June 19, 1991  
Fort St. Vrain  
Unit No. 1  
P-91211

Docket No. 50-267

SUBJECT: Natural Gas Collection Pipelines in the Vicinity of  
Fort St. Vrain - Permanent Solution to Connection  
With 16 Inch Pipeline

FIG. 1

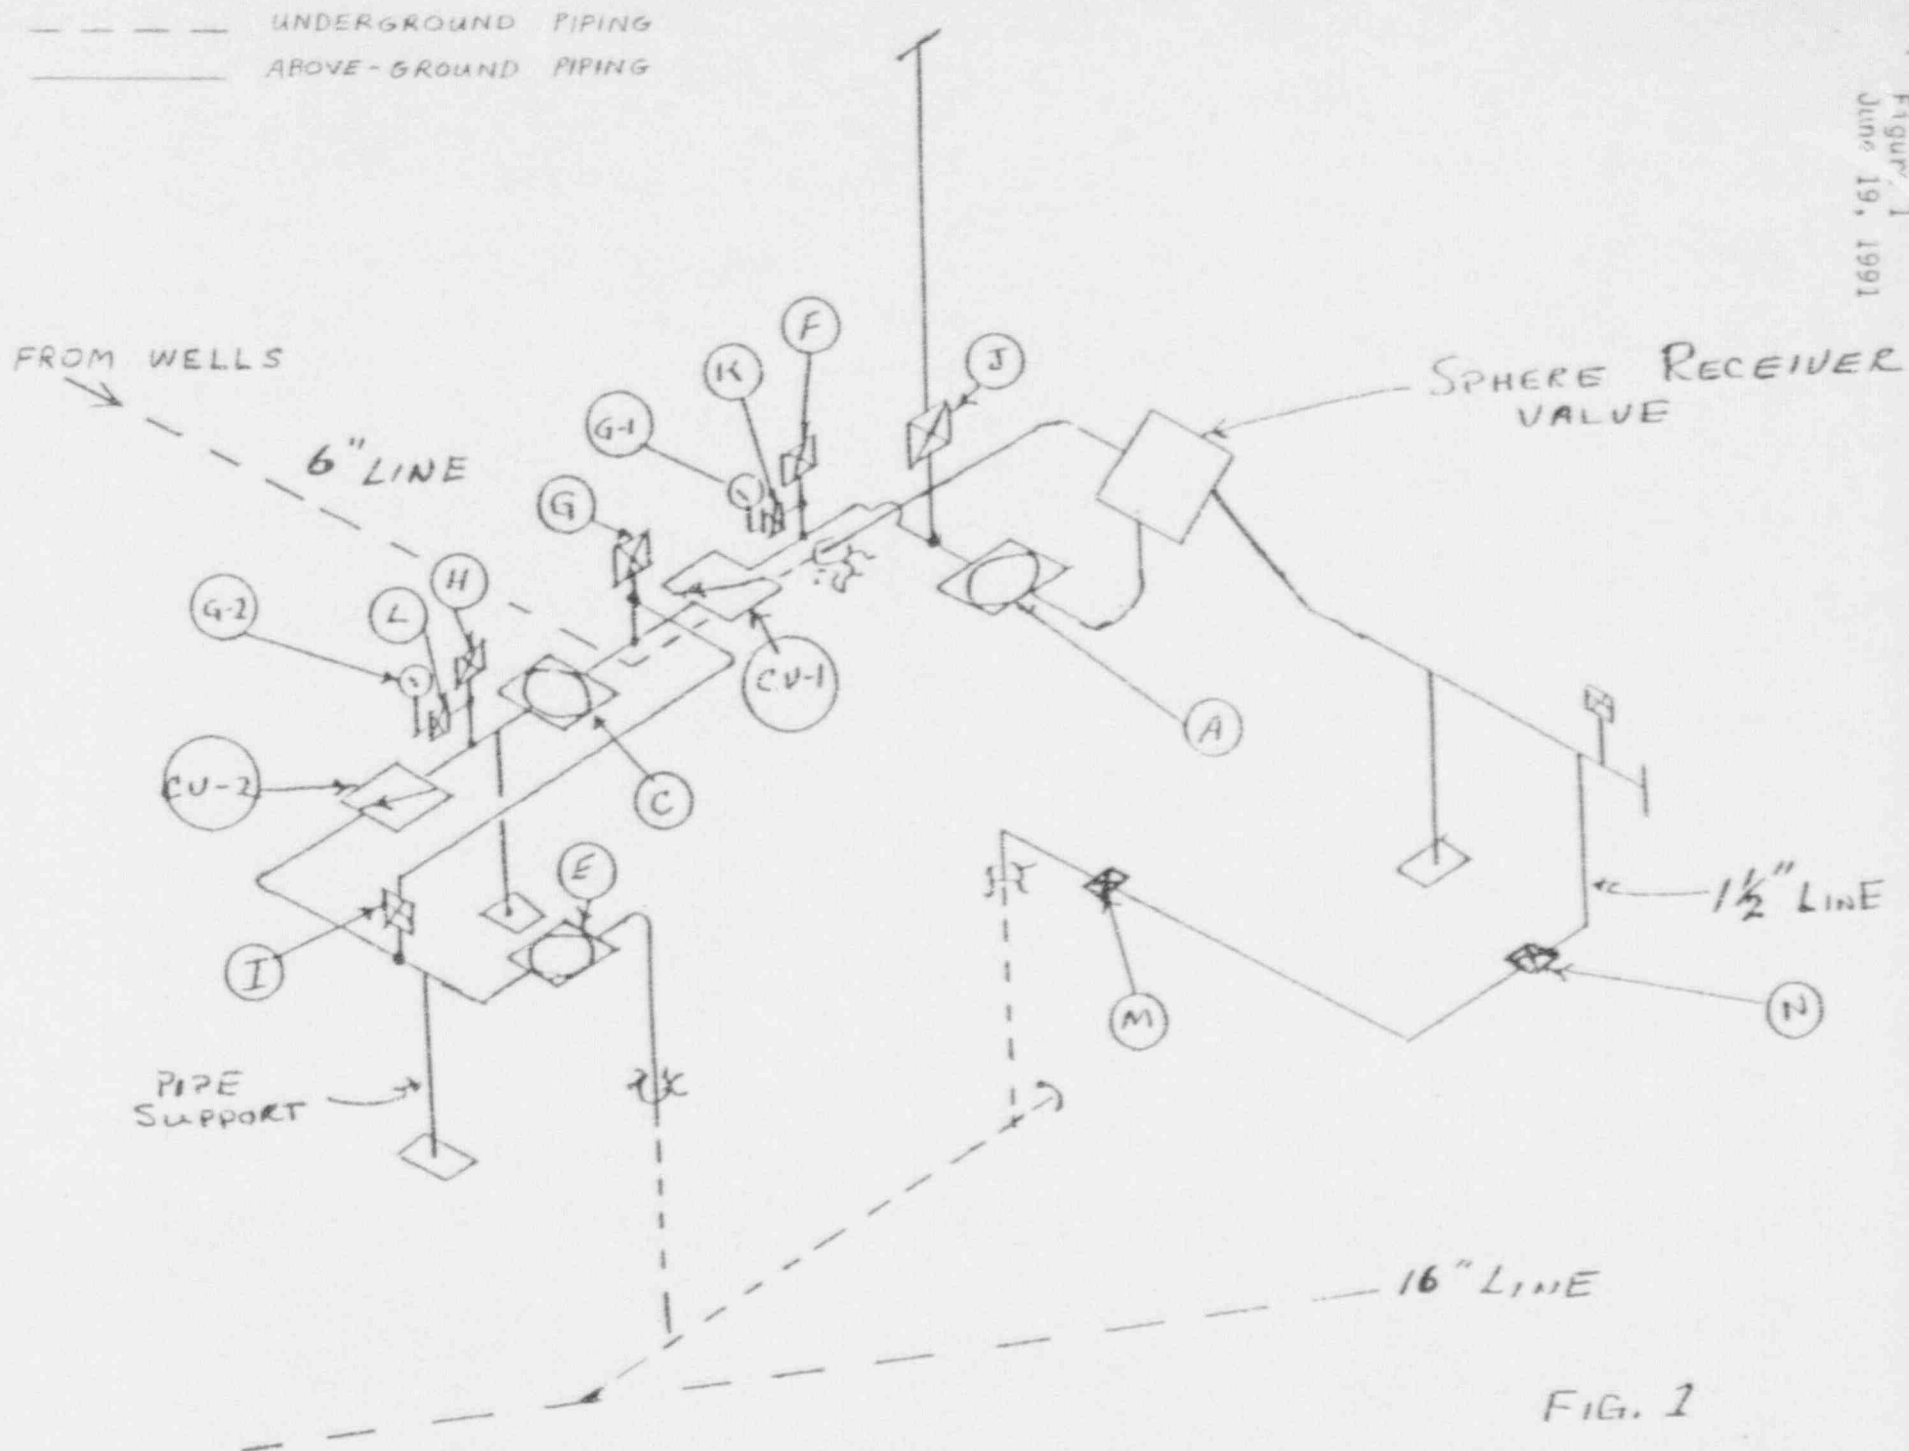
Figure 1 depicts the redundant check valve station configuration, which consists of two 6 inch check valves in series, along with the necessary isolation valves, vent valves and pressure gage connections to permit testing. Should a large rupture occur in the FSV collection piping system, the check valves would shut and isolate backflow from the 16 inch line into the 6 inch line. The valves in the 1.5 inch equalizing line are normally open, and this line would continue to connect the 16 inch line with the FSV collection piping system. However, this open equalizing line was considered in the previous analyses of postulated pipeline ruptures near the Reactor Building, and found acceptable, as documented in Reference 2.

Attachment 1 presents the specifications of the new valves associated with the proposed modification. The valves are identified with letters in Figure 1, and the information on the valve types, corresponding to the letter identifiers, is provided in Attachment 1.
